WTC DRAWING
BOOK 19
AB-1–K-1055

SKILLING, HELLE, CHRISTIANSEN, ROBERTSON — Structural & Civil Engineers

PROJECT: THE WORLD TRADE CENTER | TITLE: DRAWING BOOK 19 - REVISIONS AFTER FABRICATION | DATE: 5/18/73

TITLE: REVISION AFTER FABRICATION DETAIL 904

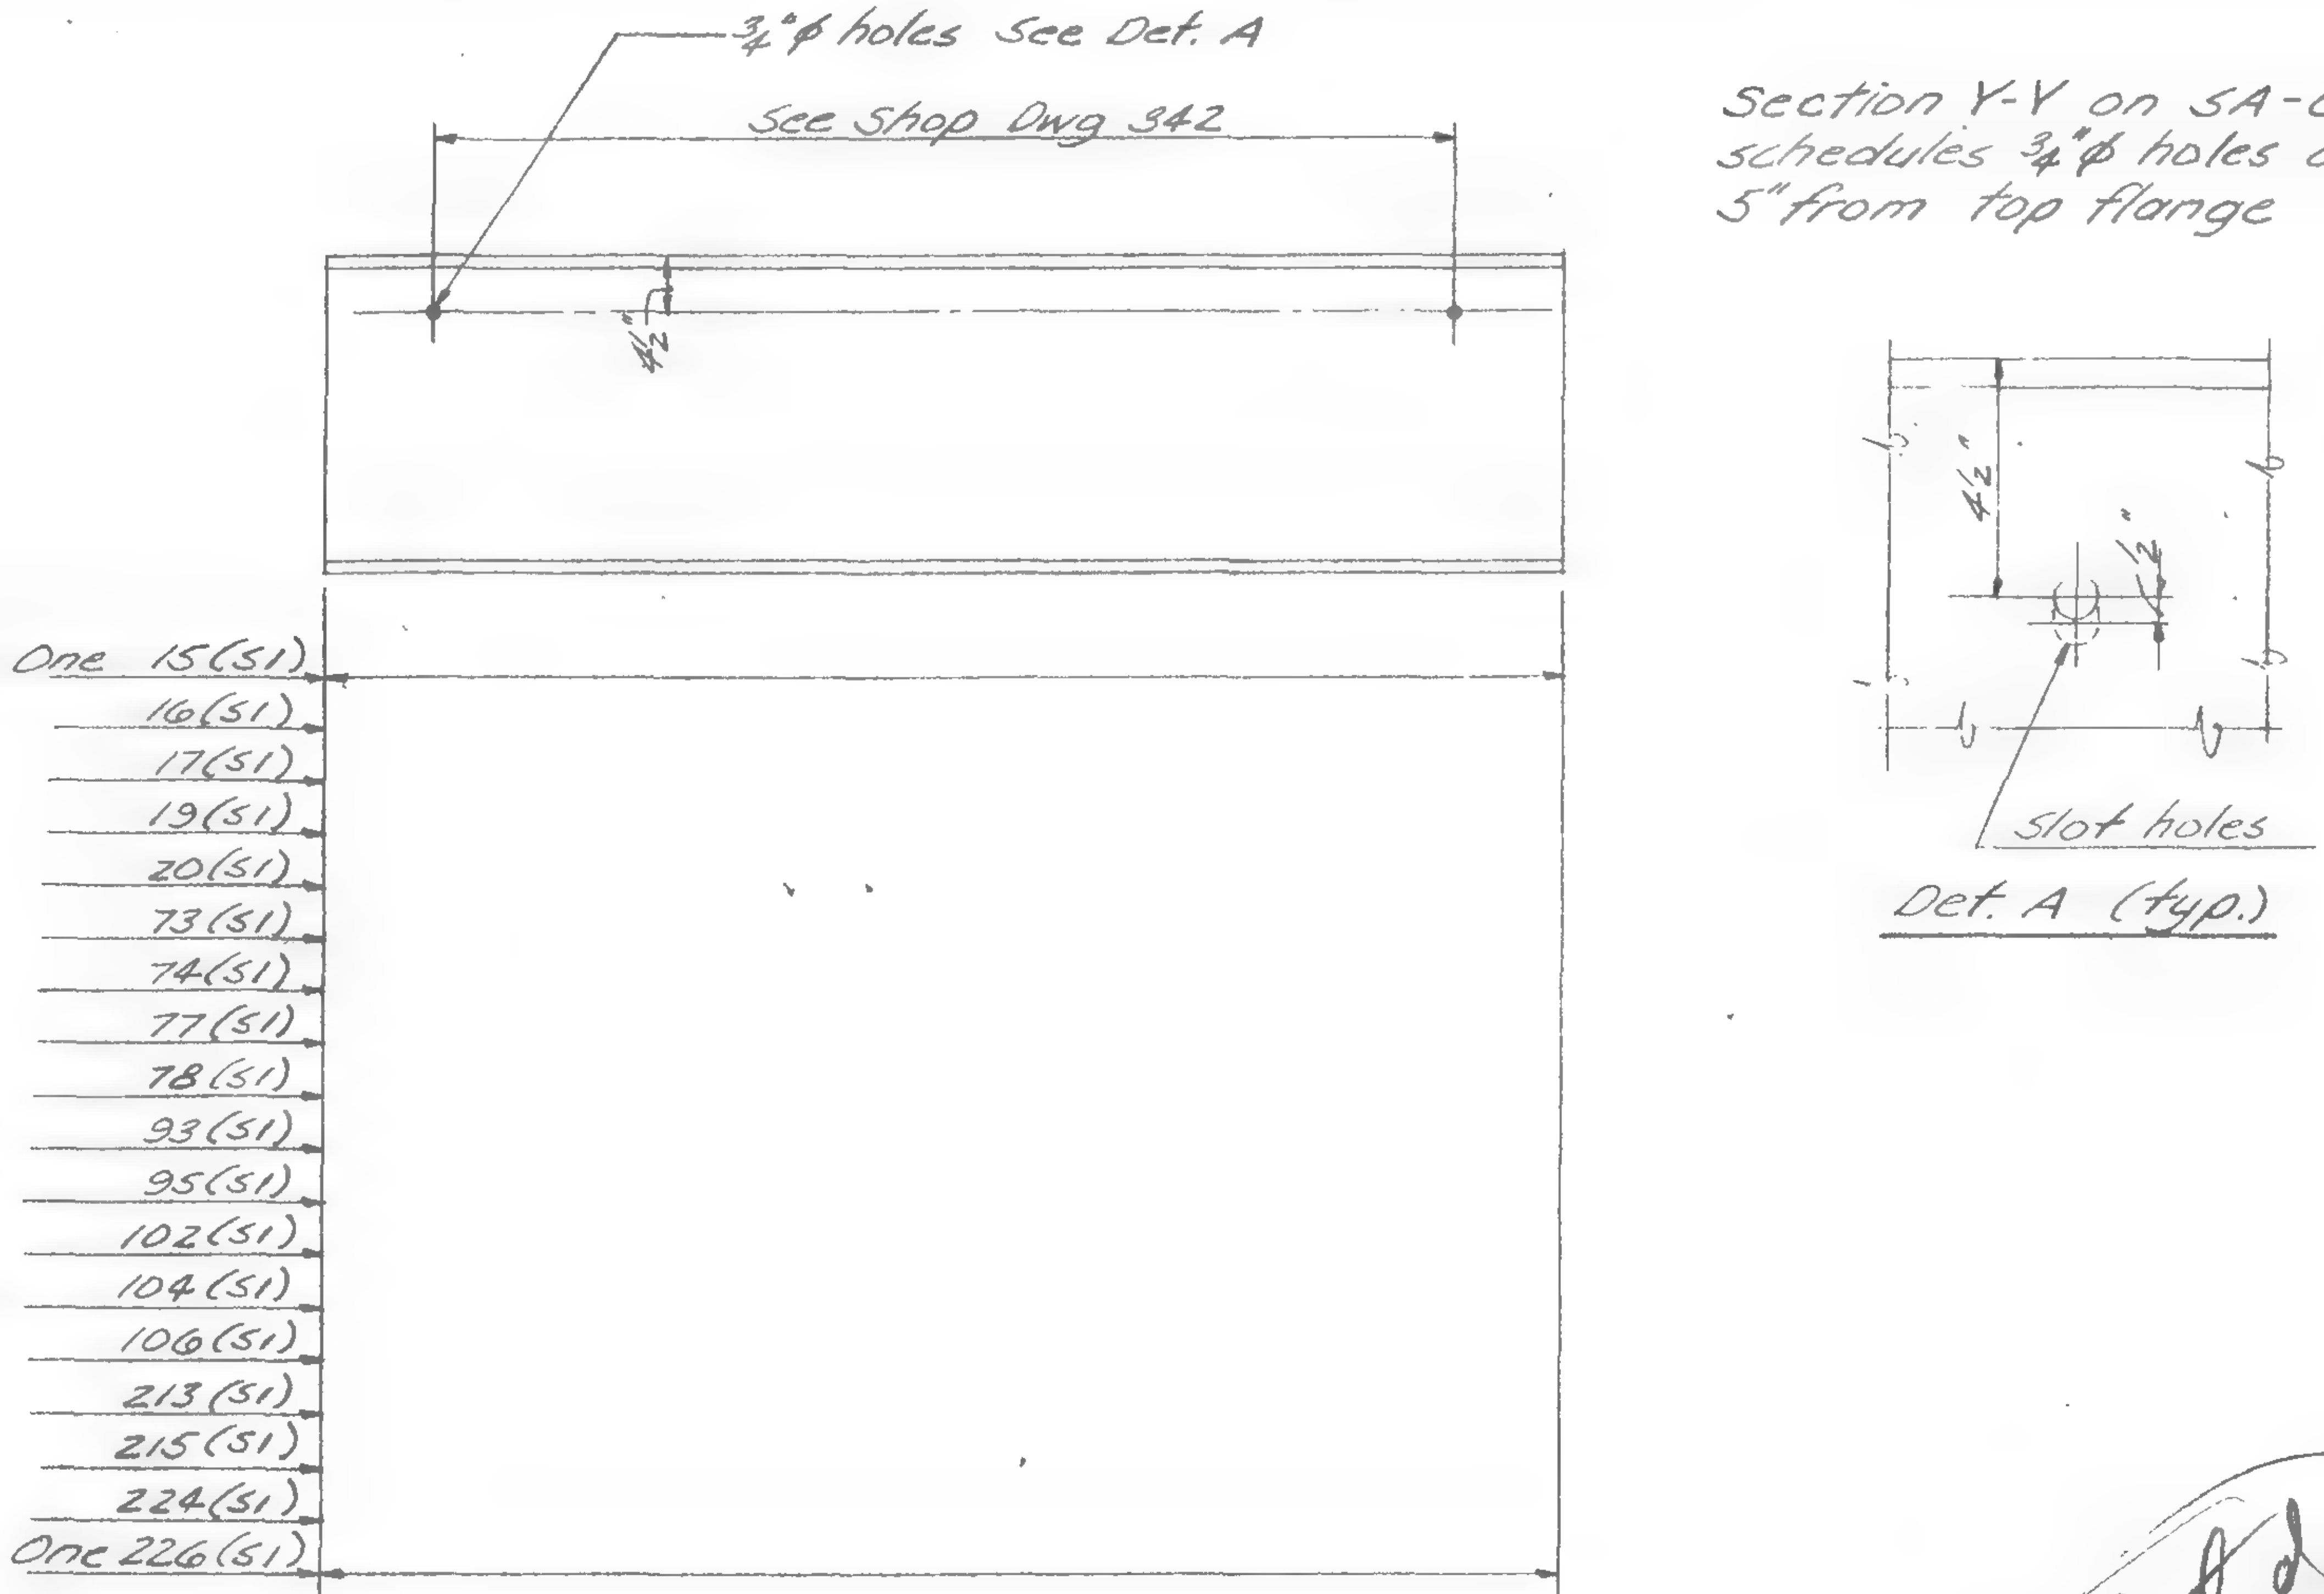
deleted from Set before 1st issue - change Slip SHCR 095 disapproved by NIL of PNYA UAB

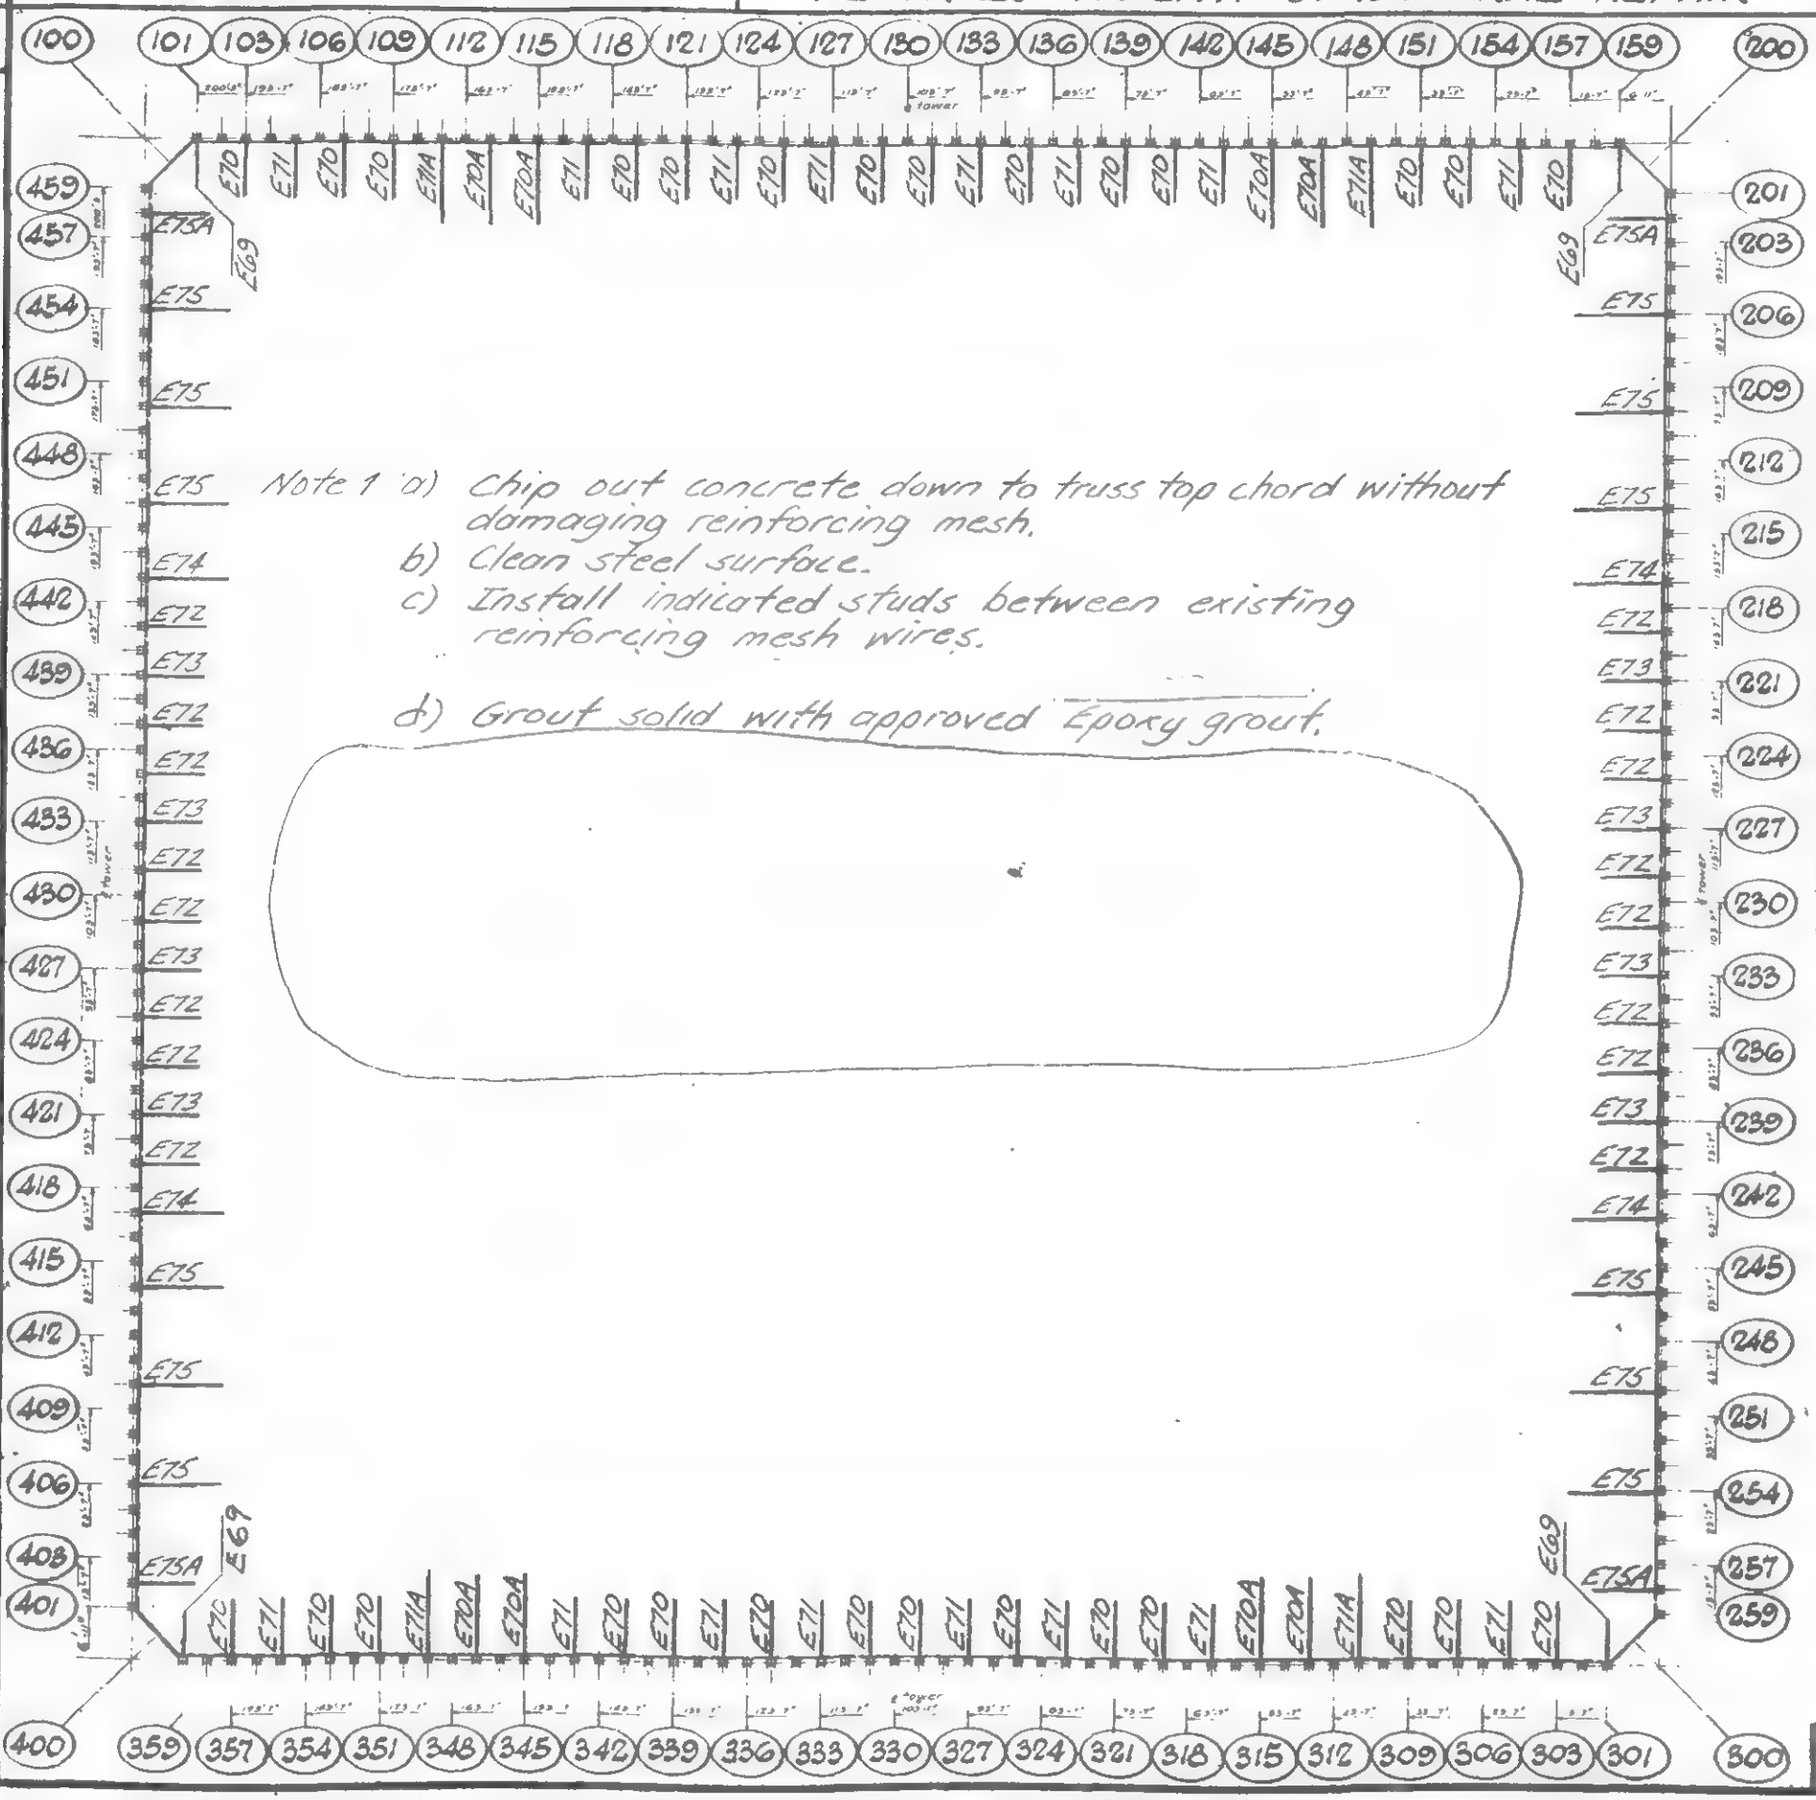
Note 1 a) Chip out concrete down to truss top chord without damaging reinforcing mesh.
b) Clean steel surface.
c) Install indicated studs between existing reinforcing mesh wires.

d) Grout solid with approved Epoxy grout.

PROJECT: THE WORLD TRADE CENTER | TITLE: REPAIR OPENING FLOOR 7 - TOWER A - ALT.#2 | DATE: 8-7-10

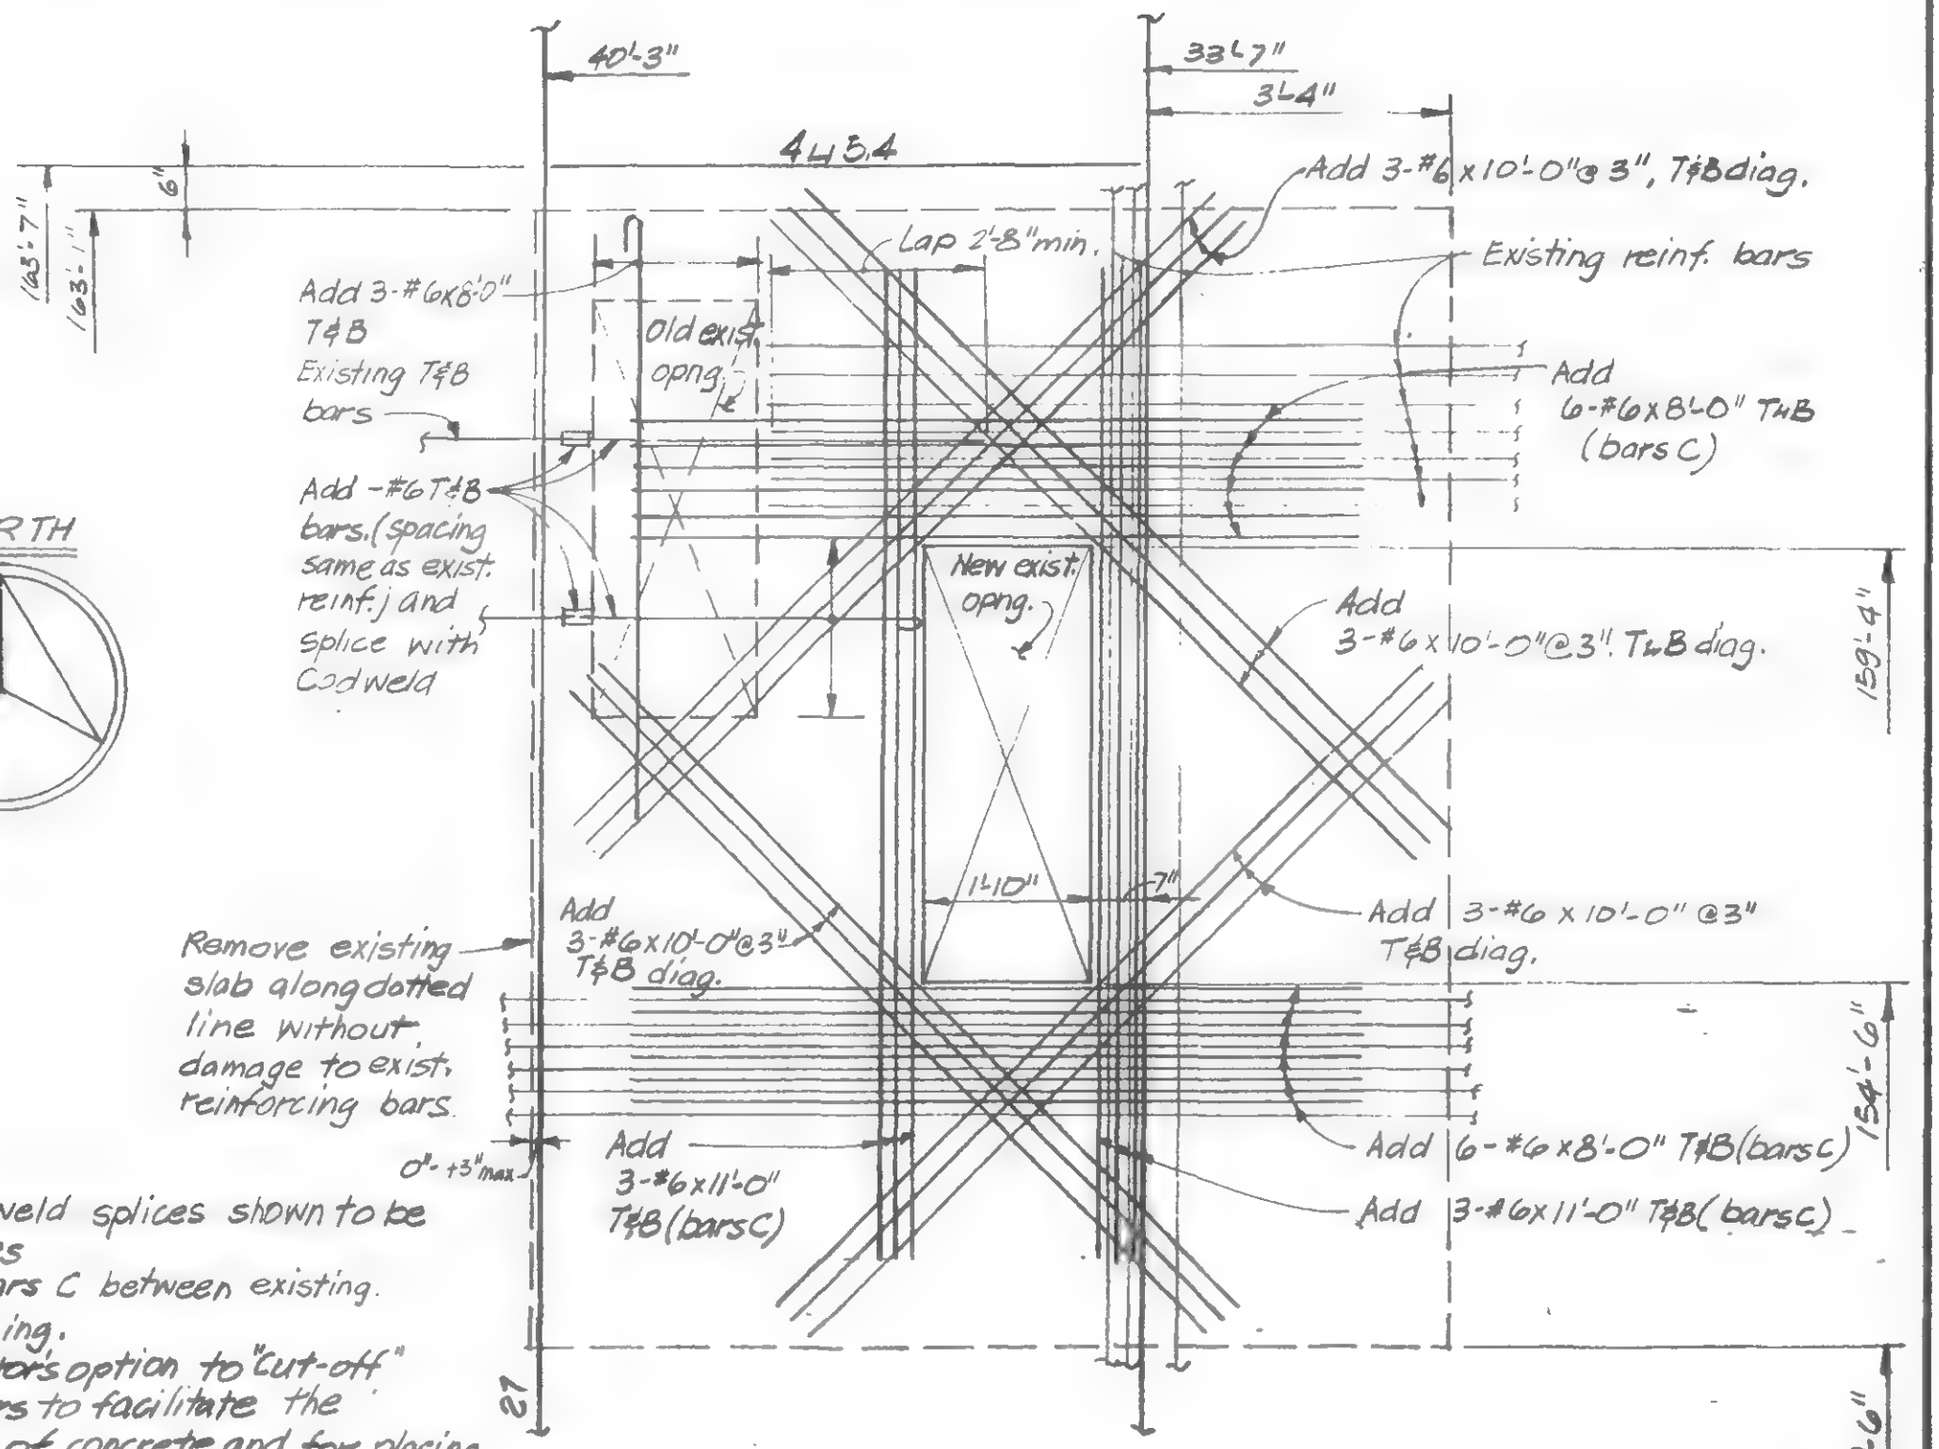
1. All Cadweld splices shown to be T-series
2. Place bars C between existing reinforcing.
3. Contractors option to "cut-off" other bars to facilitate the removing of concrete and for placing of reinforcing however bars must be replaced and connected by Cadweld splices.
4. All concrete to be non-shrinkage with $f'_c = 4000$ psi
